## **ADDENDUM NO. 2**

### **2013 - Adirondack Loj Road Bridge Replacement**

**Essex County, NY**

**June 19, 2013**

NOTES	
DRAWING NO.	SHT. <u>1</u> OF <u>1</u>
<b>N-1</b>	REV. <u>3</u>

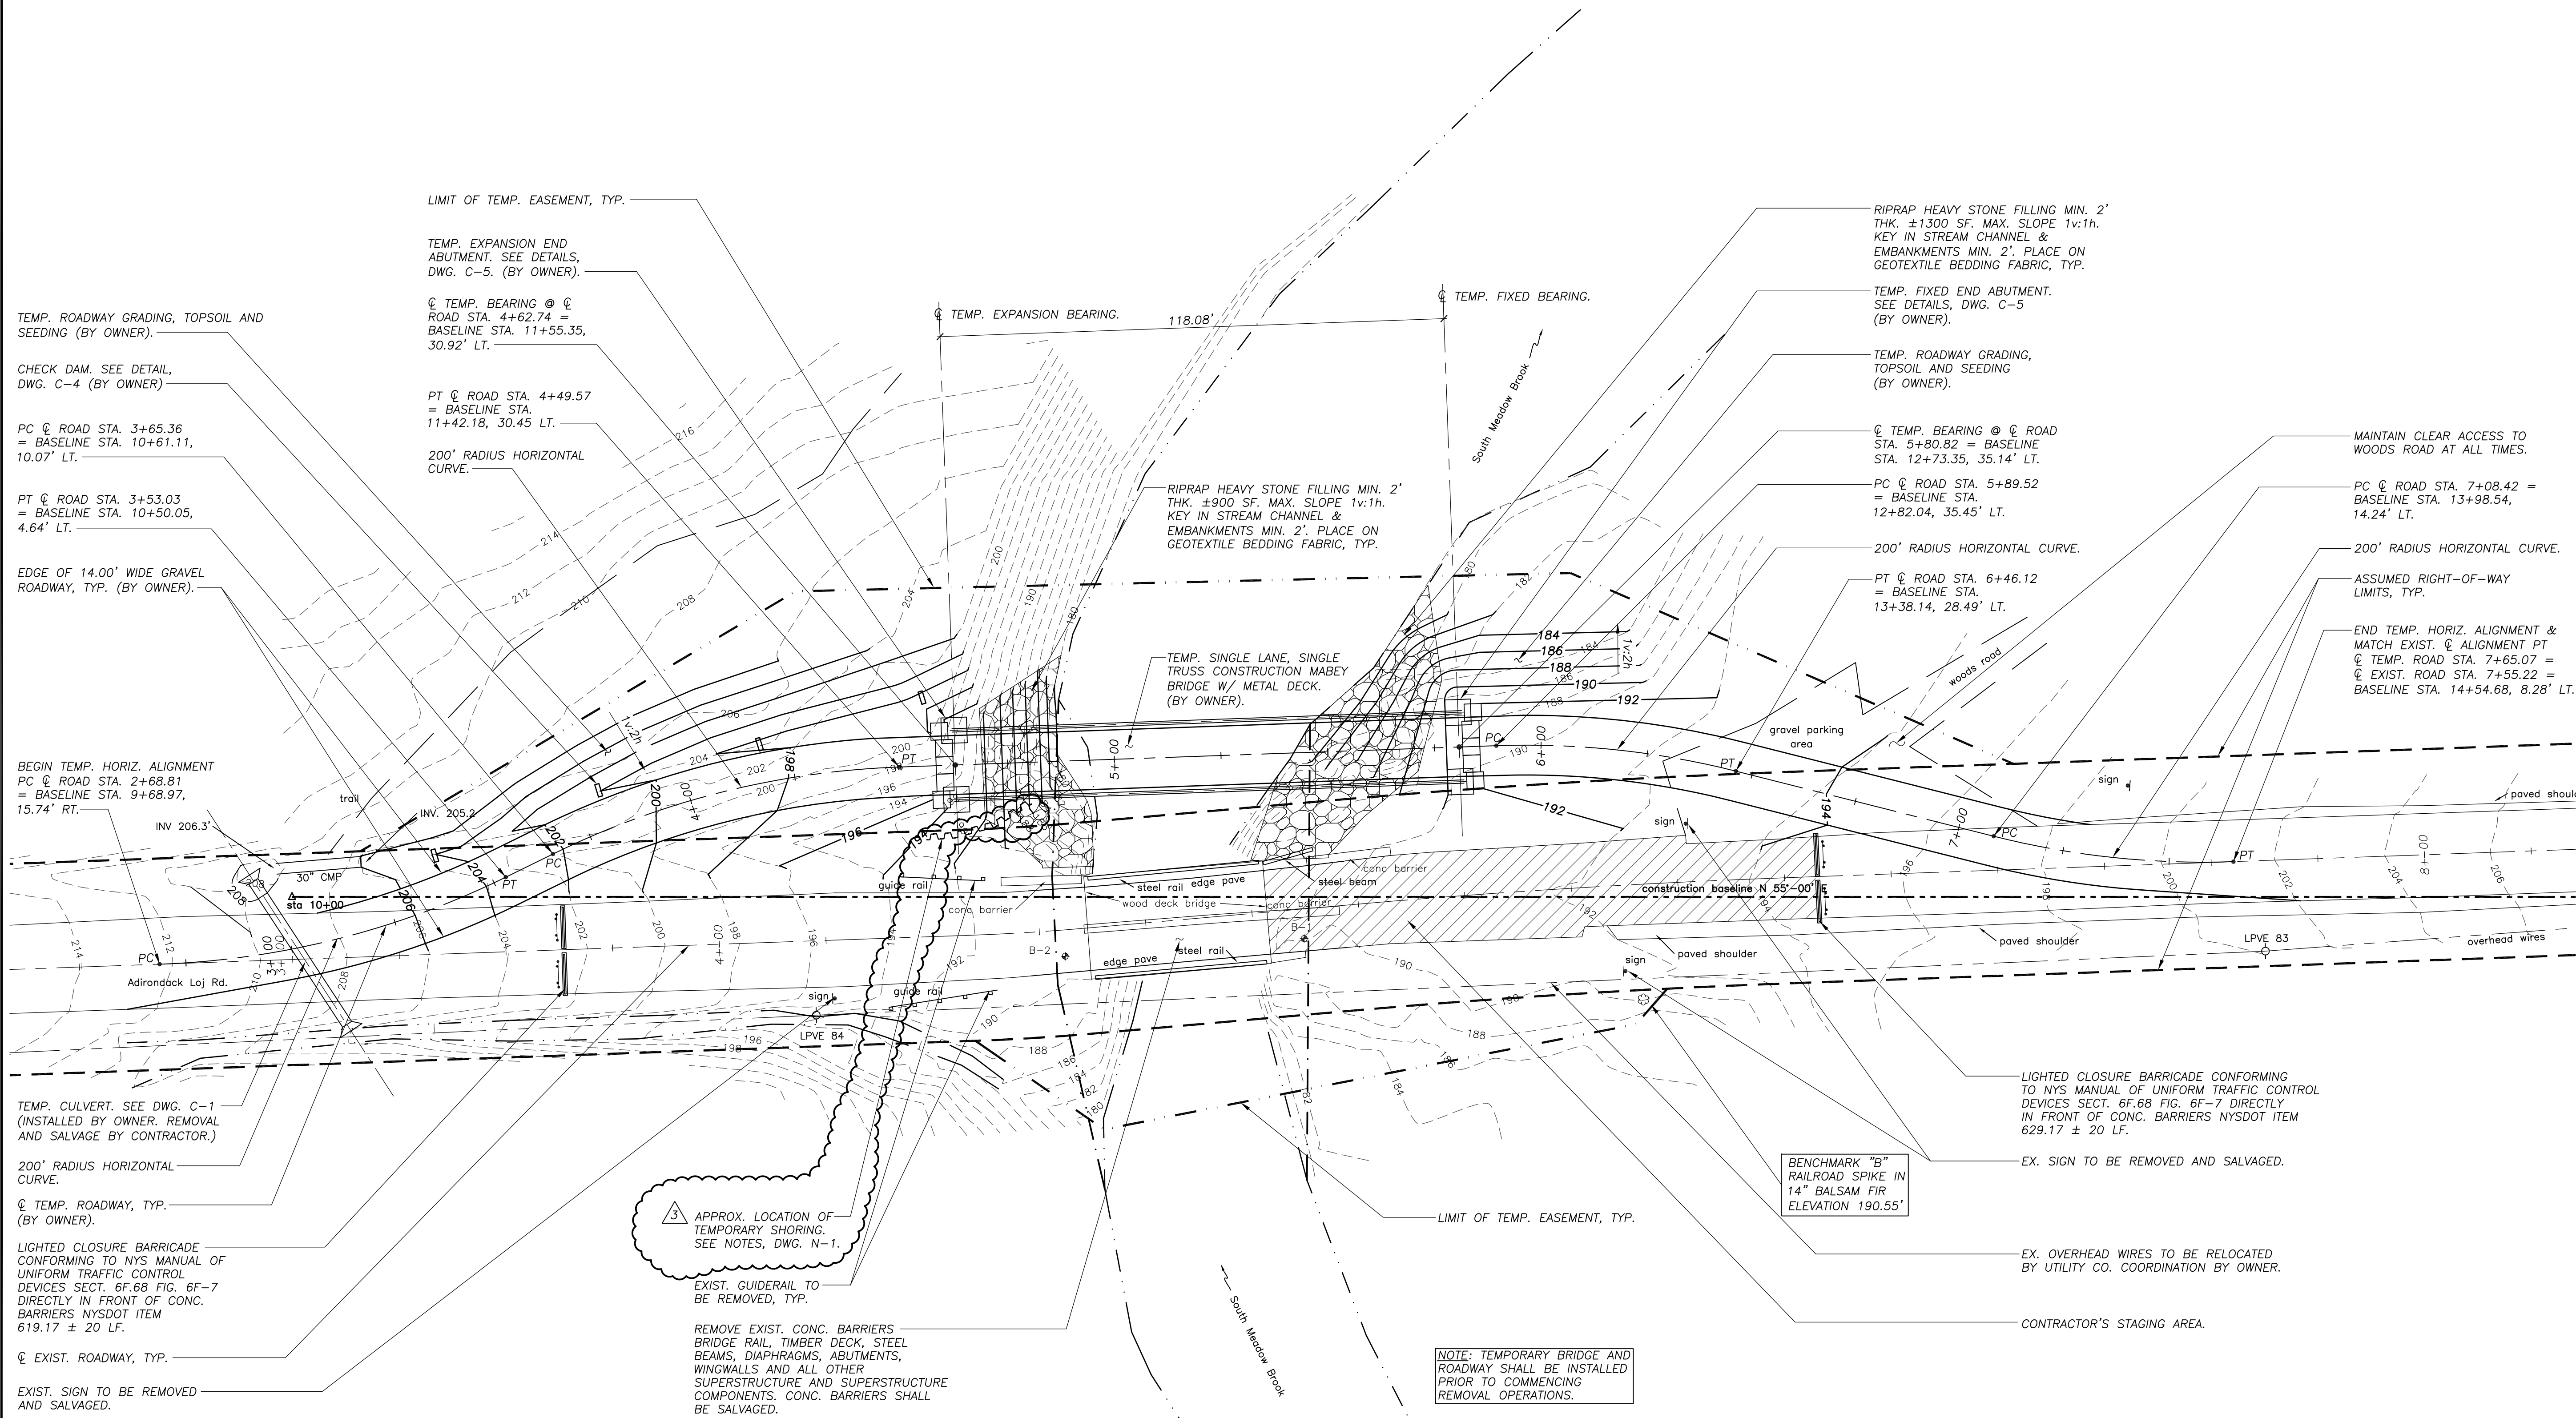
1. **General:** A Pre-Bid meeting was held for the project at the site on June 18, 2013 at 9:30 AM. Minutes from the meeting are enclosed and are a part of this Addendum.
2. **Regarding the Drawings:** DELETE previously issued Drawings N-1, C-2, C-3, S-2 and S-3 and SUBSTITUTE THEREFORE the enclosed Drawings N-1, C-2, C-3, S-2 and S-3 all bearing the Revision Date 06/19/13.

4. Schoder noted that cold-formed sheetpile shapes would be acceptable for the project. This modification will be addressed in Addendum No. 2.
5. Bidders asked if the low-strength concrete to be installed for the mud mat below the abutment and wingwall footings could be placed below water using tremies. NYSDEC General Permit GP-5-12-001 Permit Condition No. 23 on Page 5 of 9 of the attached permit precludes the placement of concrete below water so as to displace water from within the formworks. Therefore, the placement of concrete below water is not permitted.

1. ALL SHEET PILING SHALL CONFORM TO NYSOT STANDARD SPECIFICATION SECTION 552 FOR PERMANENT SHEETING. SHEET PILE SECTIONS SHALL CONFORM TO ASTM A328M.
2. SHEET PILING SHALL BE PZ 22 SECTIONS WITH A MINIMUM THICKNESS OF 0.375" AND A MINIMUM SECTION MODULUS OF 18.1 CUBIC INCHES PER FOOT. ALL SHEET PILES SHALL CONSIST OF NEW MATERIAL. COLD ROLLED SHEET PILING SHAPES MAY BE ACCEPTABLE PROVIDING THE THICKNESS AND SECTION MODULUS ARE GREATER THAN OR EQUAL TO THE MINIMUM VALUES OF THE PZ 22 SECTION SPECIFIED ABOVE.

DRAWING NO.	SHT. 3 OF 5
<b>C-3</b>	REV. 3

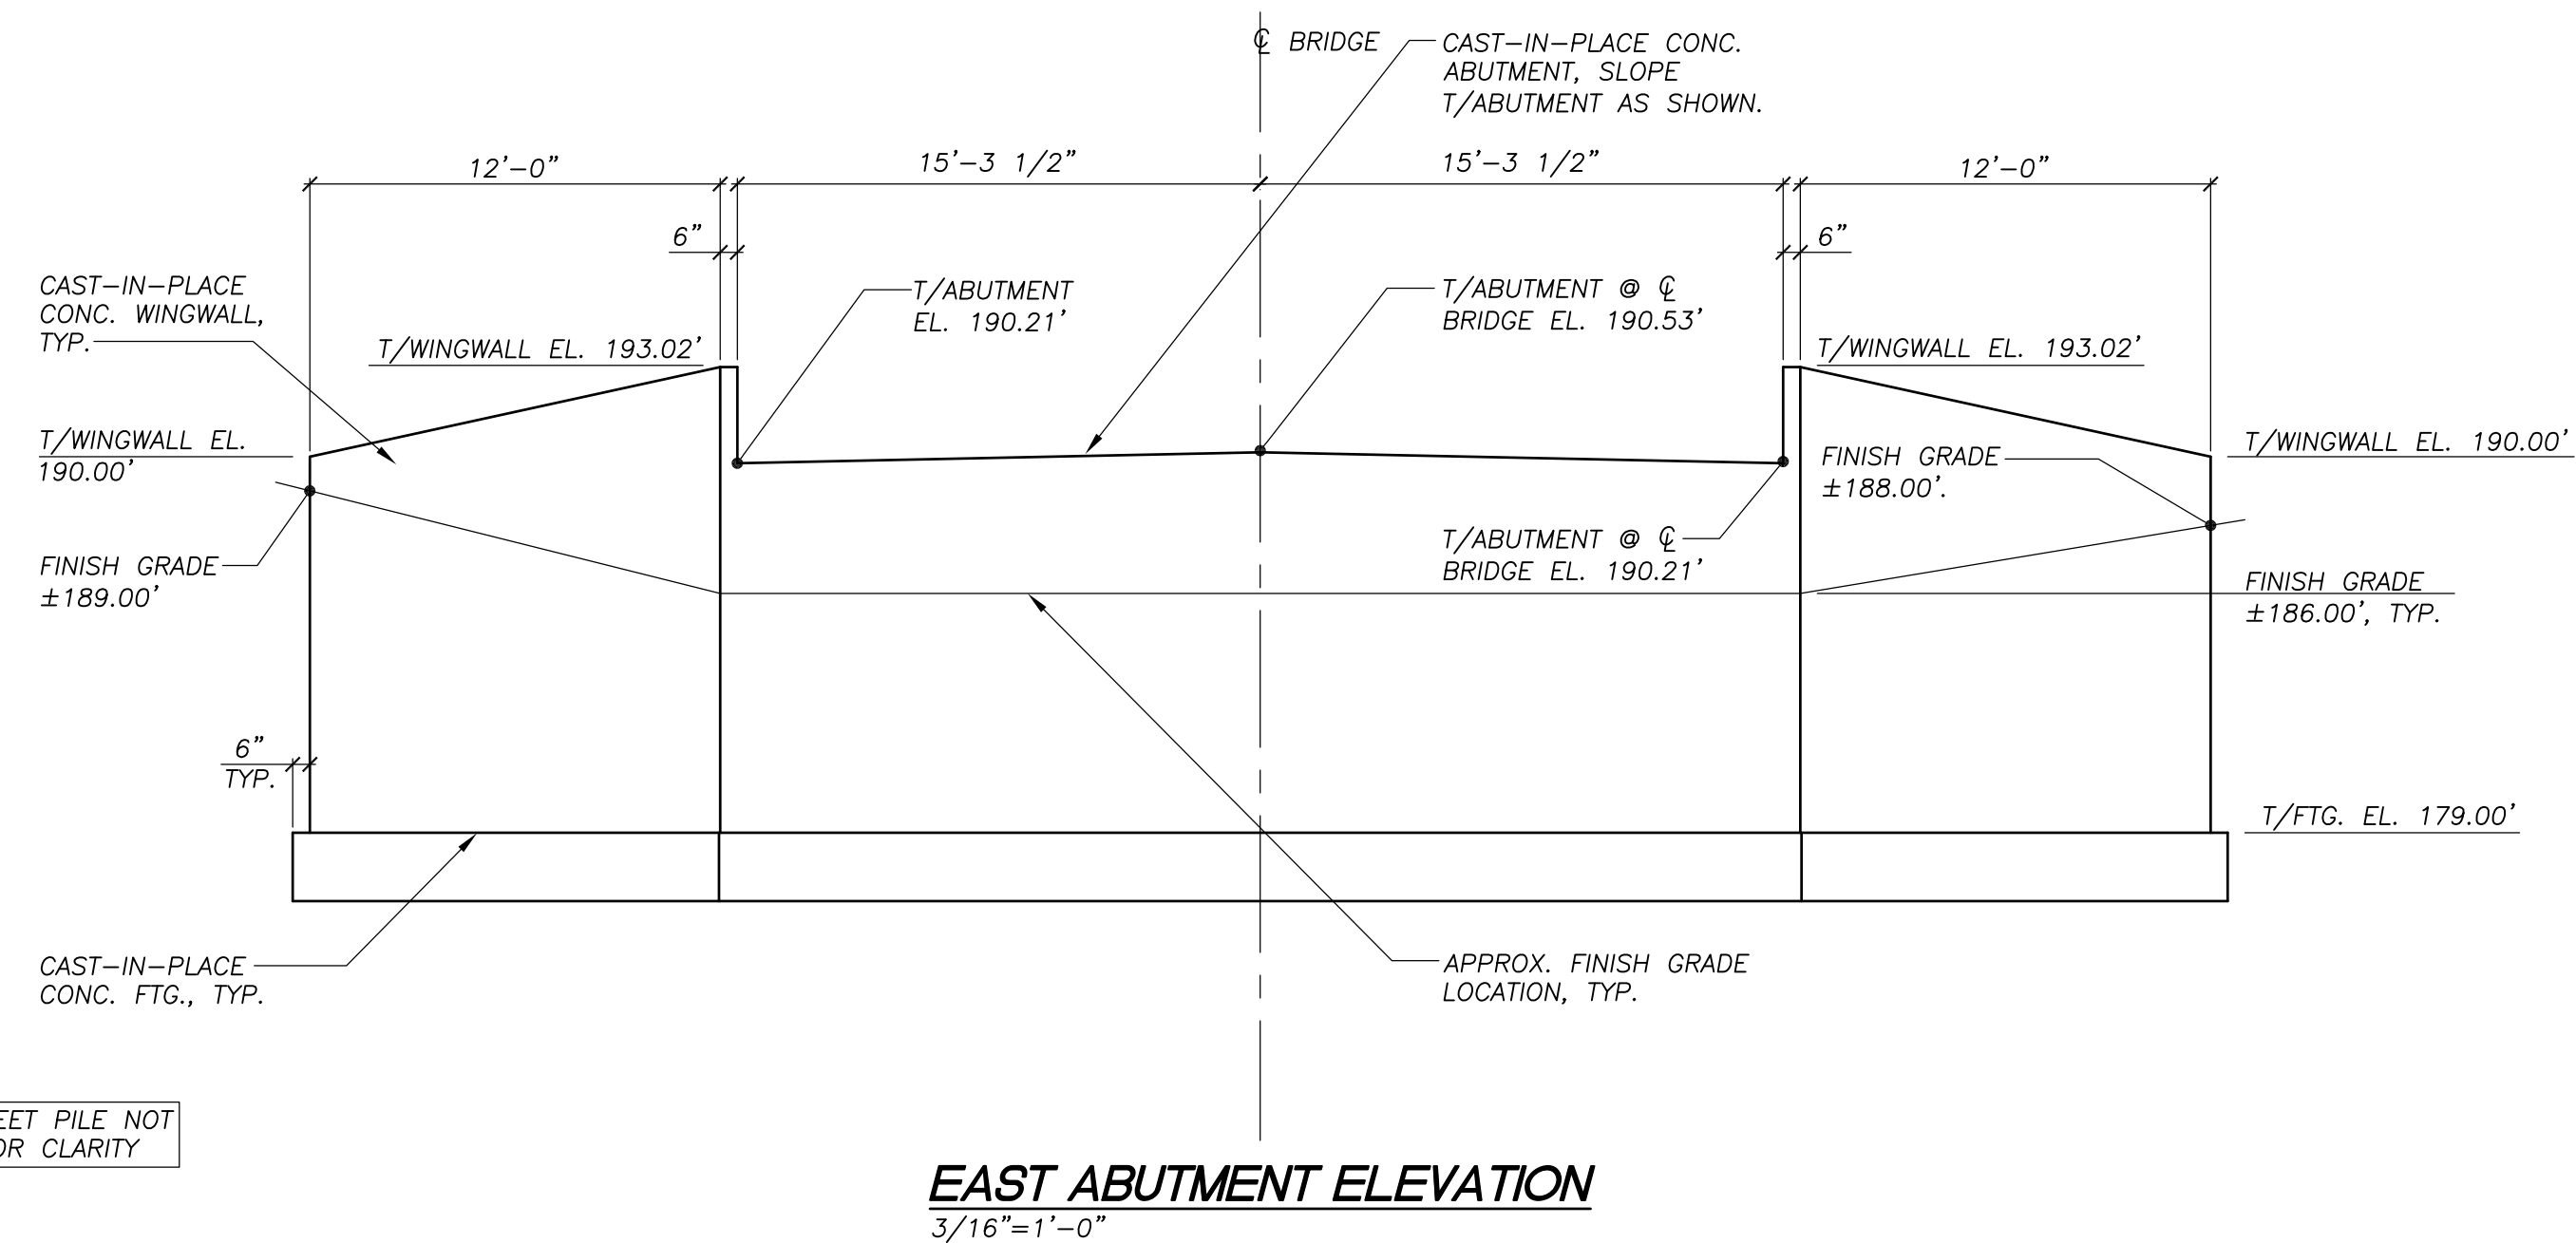
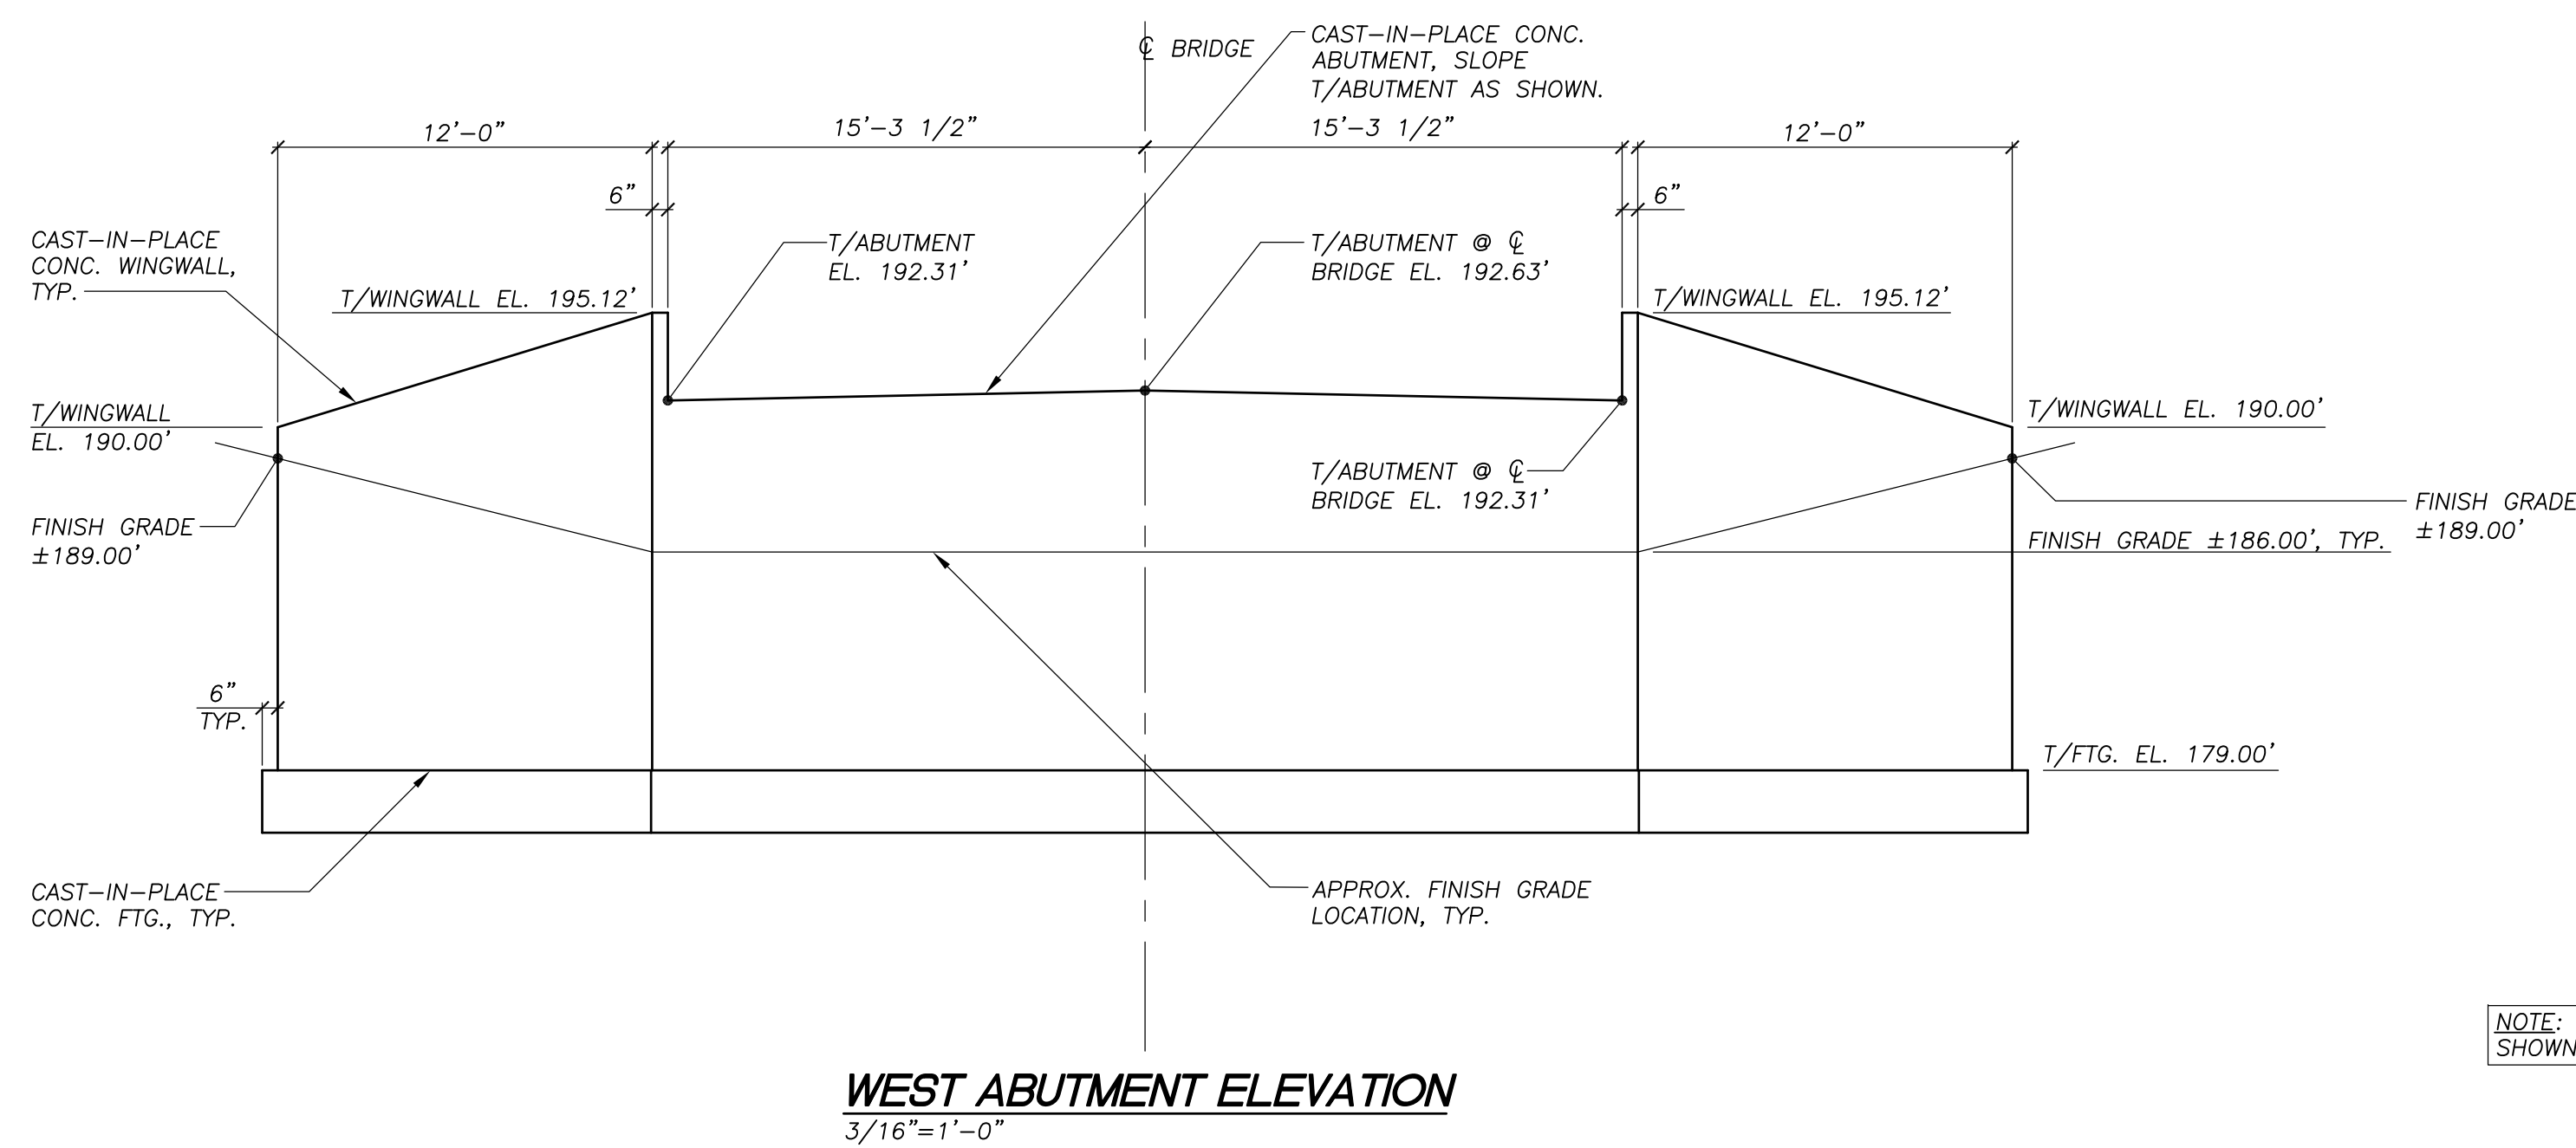
3. Schoder noted that the sheet pile scour protection at the abutments indicated on Drawings S-2 and S-3 must be driven to the depths indicated. The bidders shall include in their bids all costs for the installation of such sheetpiling including the use of driving shoes, pre-driven H-piles to loosen existing soils for sheetpile installation, and any other means or methods determined to be necessary by the contractor for the installation of the indicated sheetpiling.
